# 3812 - Addendum 1

To	Kristen Haskell	Date	10/03/25
For	Long Creek Youth Development Center Ceiling Replacement	Project No.	BGS# 3812 SMRT# 25014

This addendum forms a part of the bidding and contract documents.

AE101

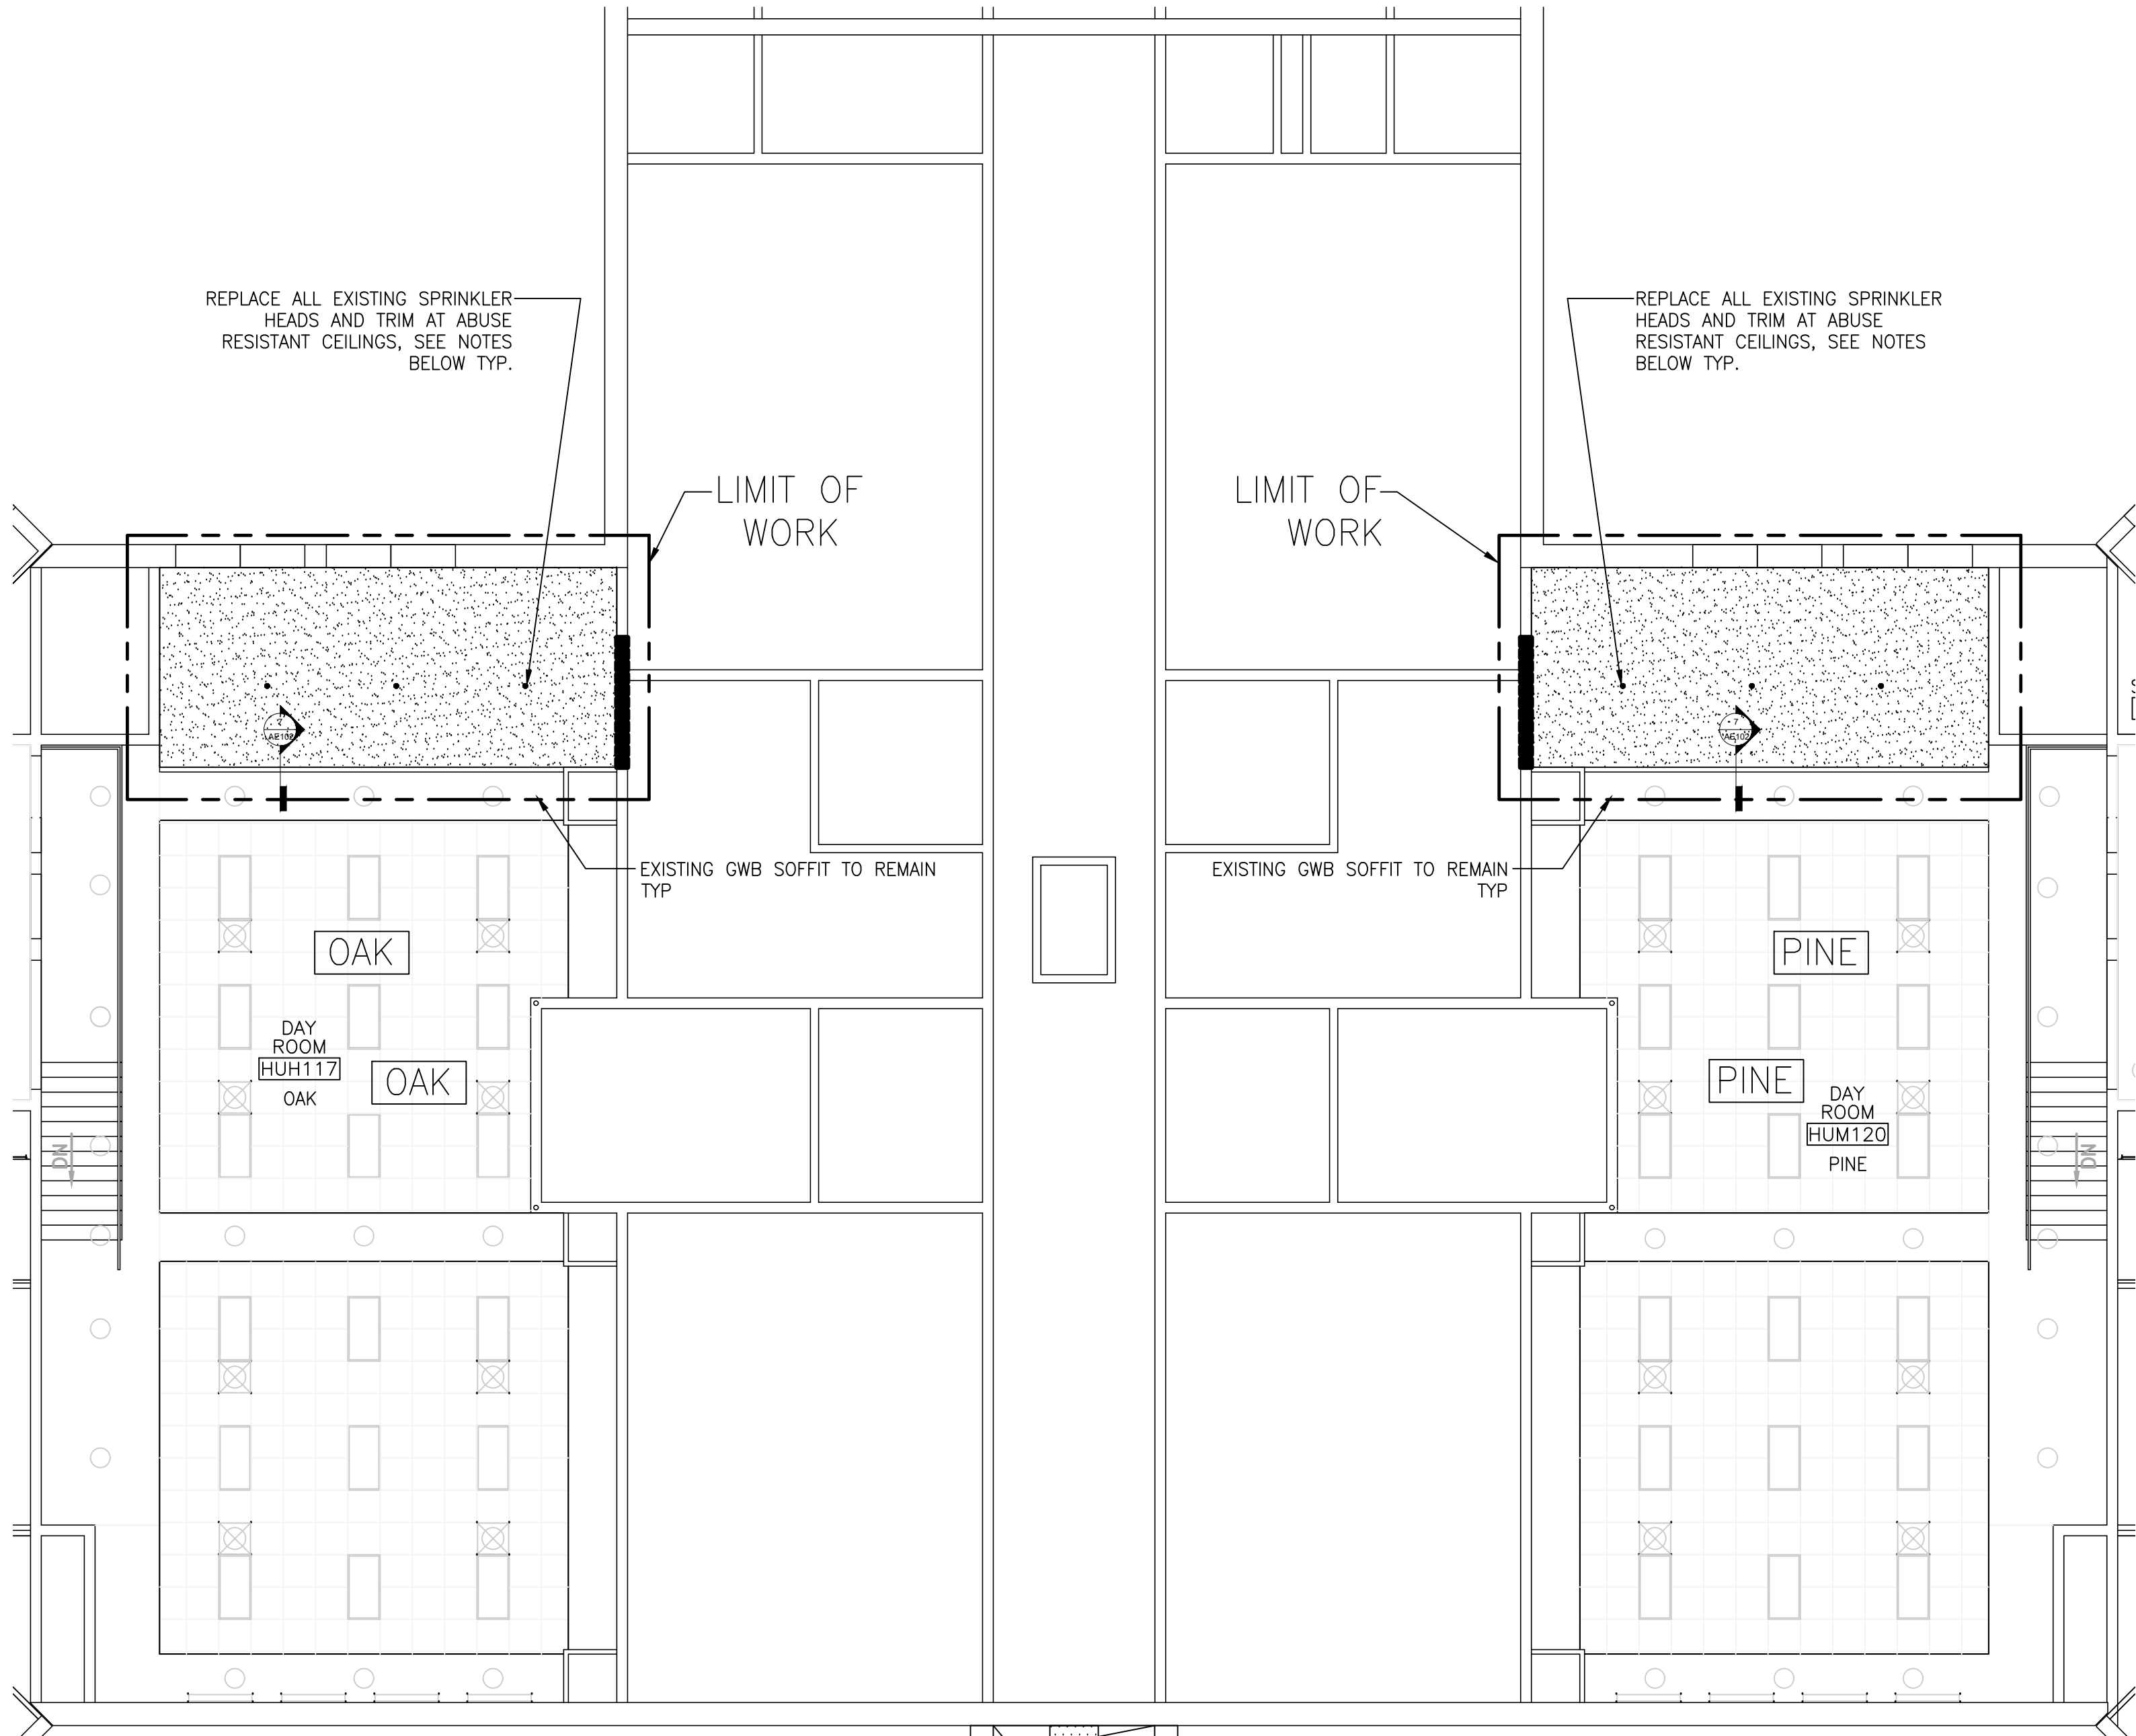
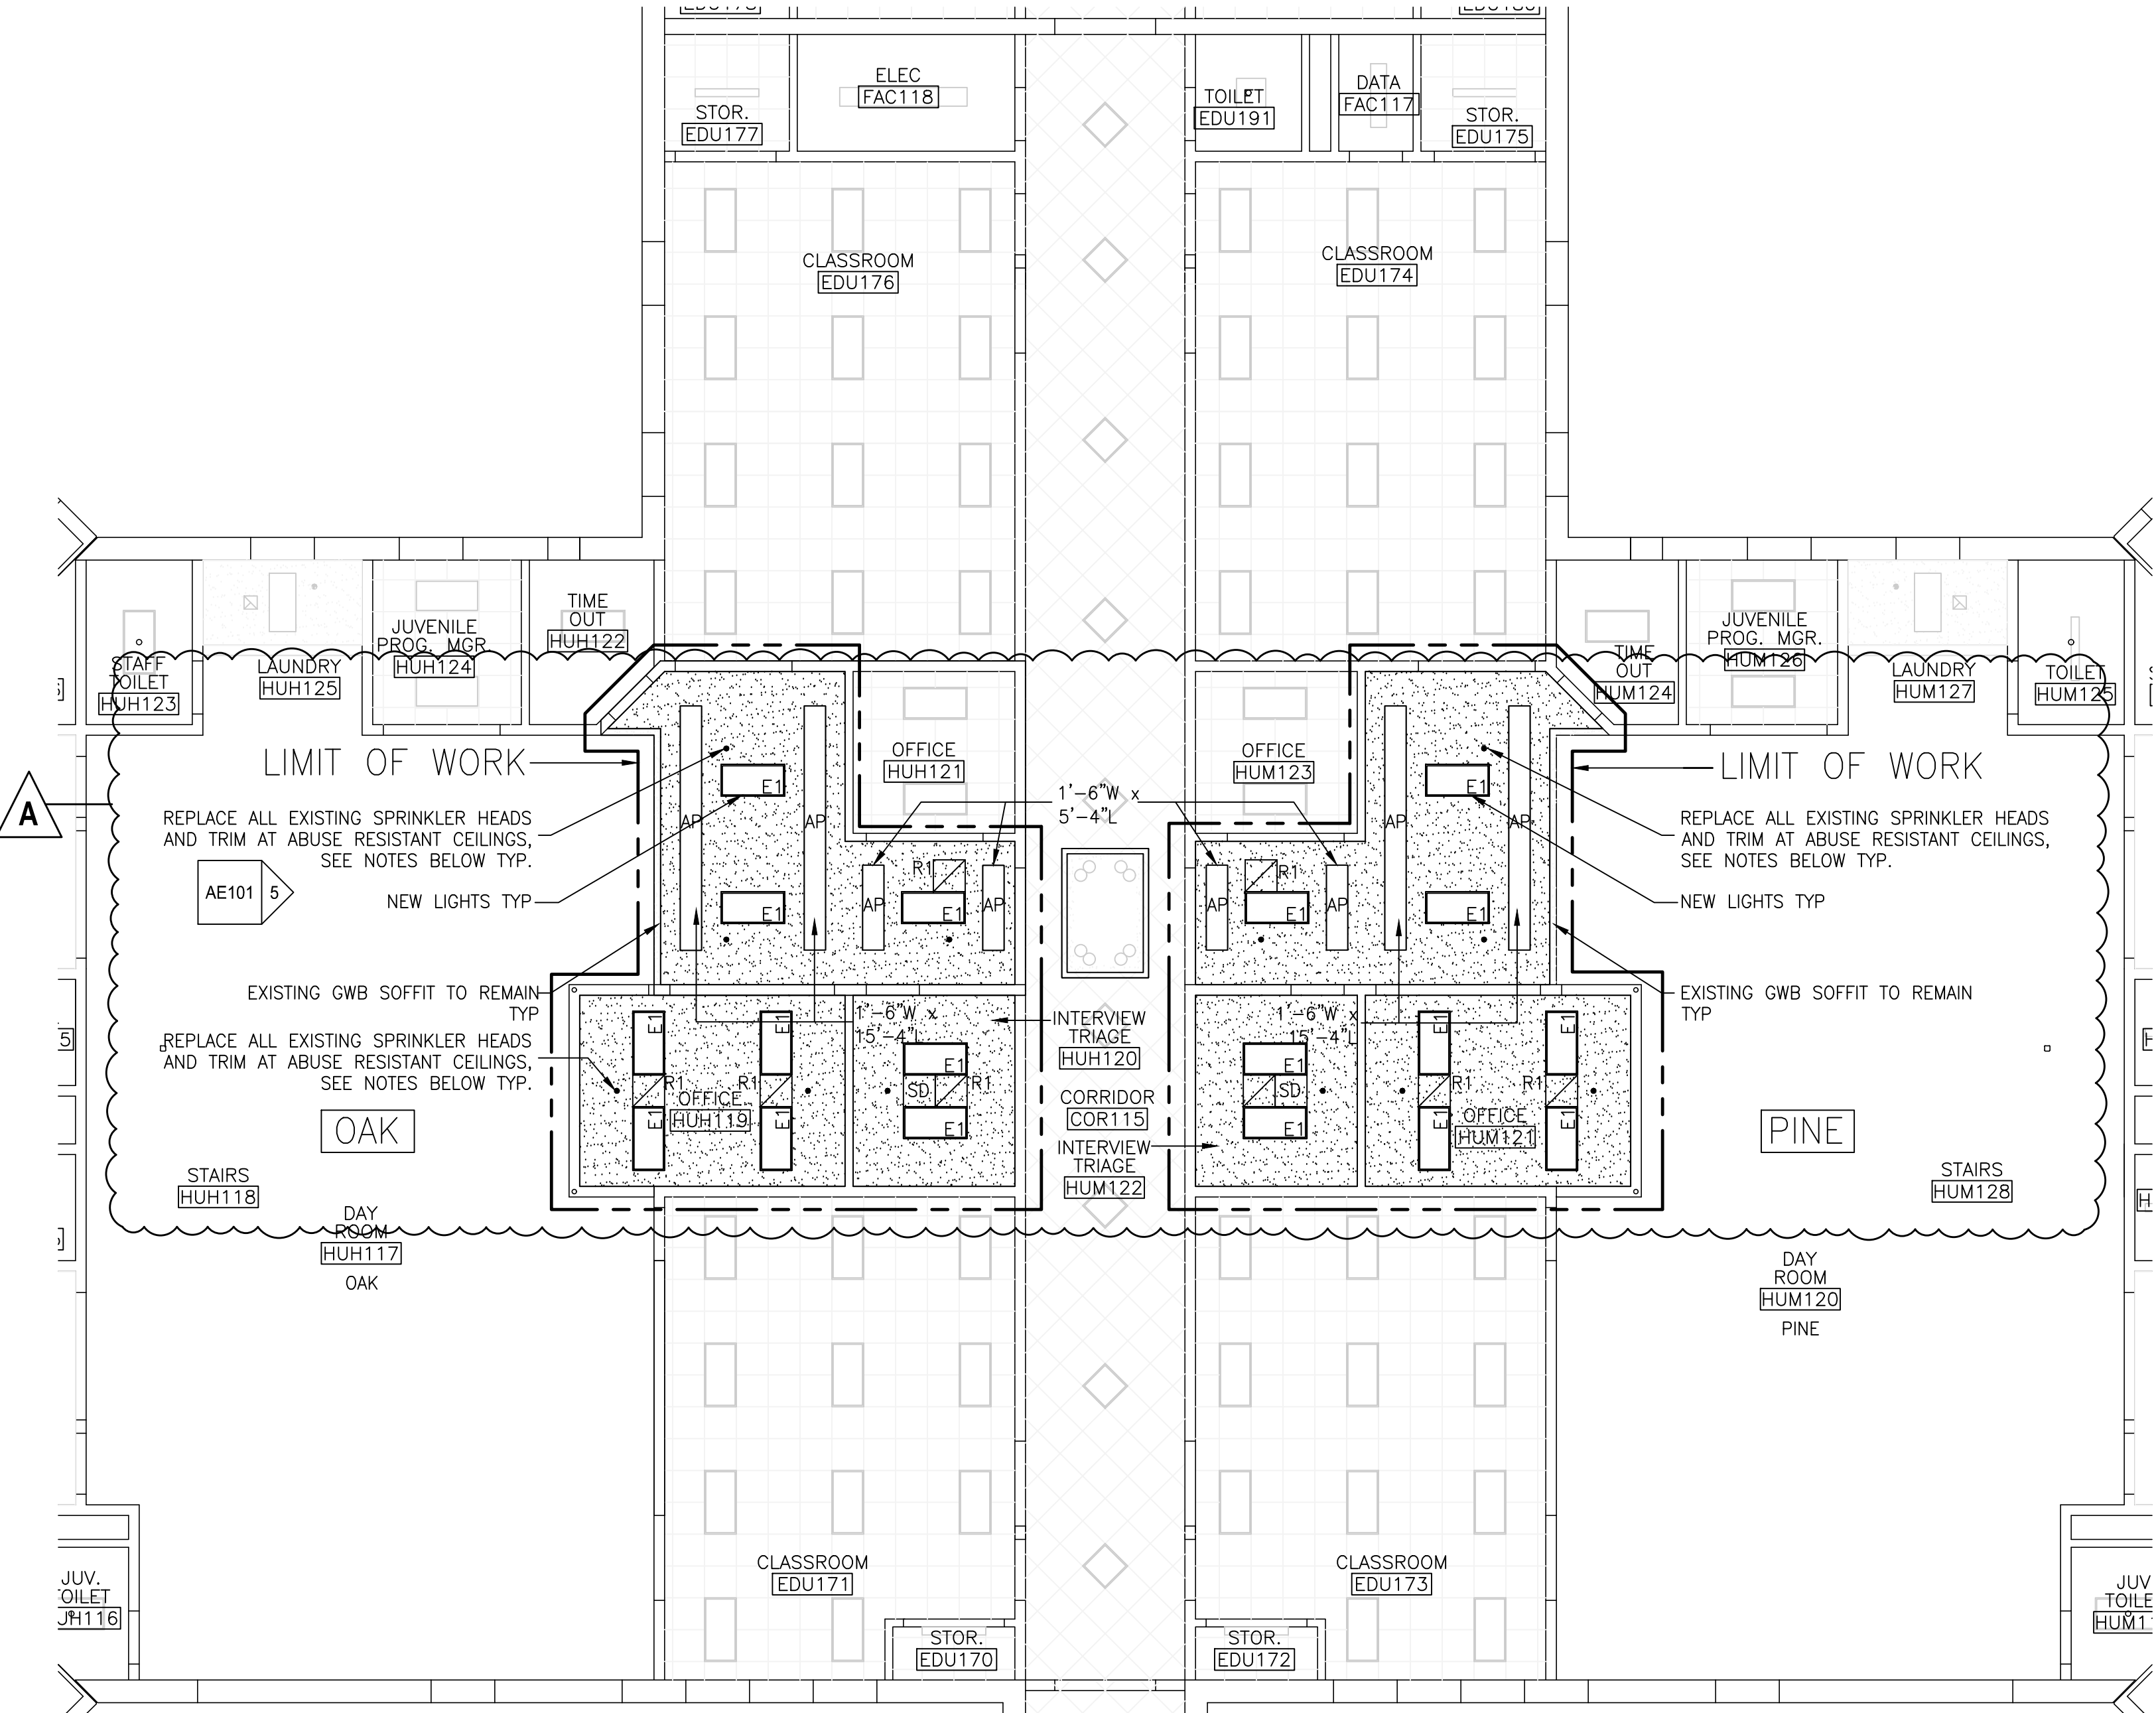
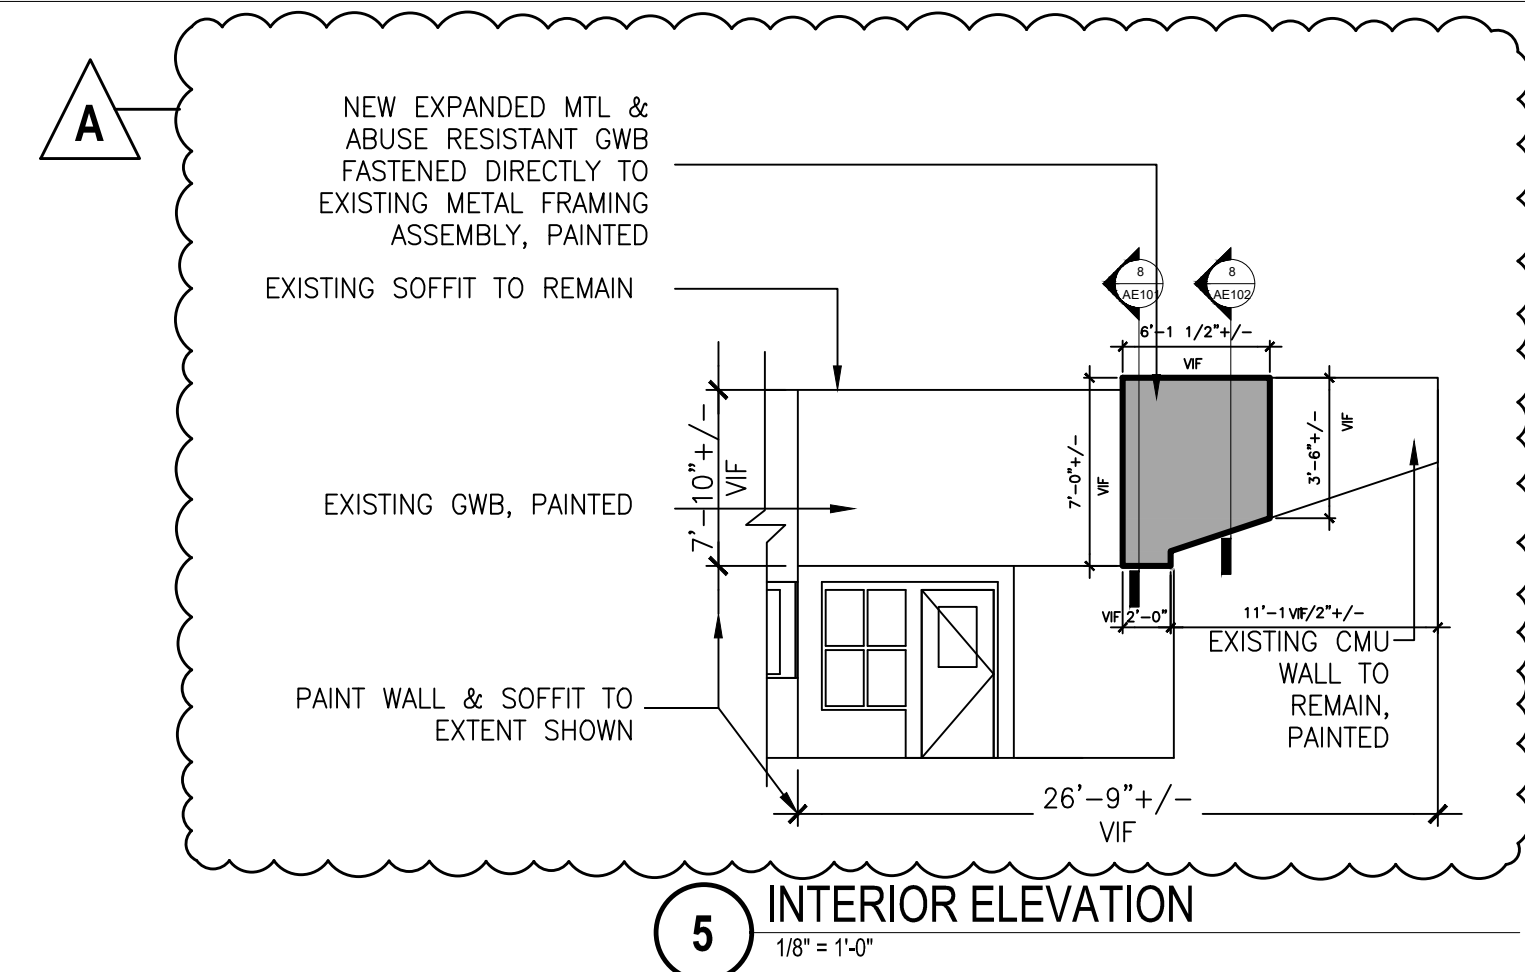
BIDDER QUESTIONS	
Q1.	Is the impact face is needed. There typically isn't a need for this type of face on the ceiling. RESPONSE: <b>Yes, the impact face is necessary.</b>
Q2.	AD102 existing pictures didn't come through on the plans? RESPONSE: <b>Refer to the attached revised drawing AD102 for photos.</b>
Q3.	Access panels are noted and mentioned to show minimum on plans? We don't see any shown. Is there a quantity we should carry with it being unknown? RESPONSE: <b>Provide (4) four security access panels within each housing unit, in addition to those called for on the reflected ceiling plans. Refer to added architectural note 10 on the attached revised drawing AE101 &amp; AE102.</b>

Q17.	For larger spans, please advise what the metal stud framing should be for the ceiling. Please provide a framing detail. RESPONSE: <b>Refer to specification section 092216 and the attached revised drawings AE101 &amp; AE102 for framing requirements.</b>
Q18.	Please advise what the metal stud framing for the new ceilings will be attached to and how it should be attached. Please provide a detail. RESPONSE: <b>Refer to specification section 092216 and the attached revised drawings AE101 &amp; AE102 for framing requirements.</b>
Q19.	What should be the finish height of the ceilings? RESPONSE: <b>Refer to the attached revised drawings AE101 &amp; AE102 for ceiling heights.</b>
Q20.	Please advise the height to the roof deck above the ceiling. RESPONSE: <b>Refer to architectural note 14 on the attached revised drawings AE101 and AE102 for bottom of steel roof deck height.</b>
Q21.	Are the walls in each room to be painted? If so, what paint and color? RESPONSE:

<b>No. Refer to the attached revised drawings AE101 &amp; AE102, and the attached revised specification section 099123 for paint scope clarifications.</b>
Q22.	Please confirm flooring is now included in this SOW. RESPONSE: <b>Flooring is not included in the scope of work. Any existing flooring damaged by construction activities would need to be replaced with new flooring.</b>
Q23.	Please advise what gauge metal studs should be installed. RESPONSE: <b>Refer to specification section 091116, 2.2, 1., a.</b>
Q24.	Please confirm no insulation is to be installed above the GWB ceilings. RESPONSE: <b>There's no insulation at the ceilings. Refer the drawings for required insulation locations.</b>
Q25.	Please advise who the existing fire alarm contractor is. RESPONSE: <b>Johnson Controls</b>
Q26.	Who services the existing fire suppression system? RESPONSE: <b>Johnson Controls</b>
Q27.	Can the superintendent be the SSHO & QCM? RESPONSE: <b>Yes.</b>
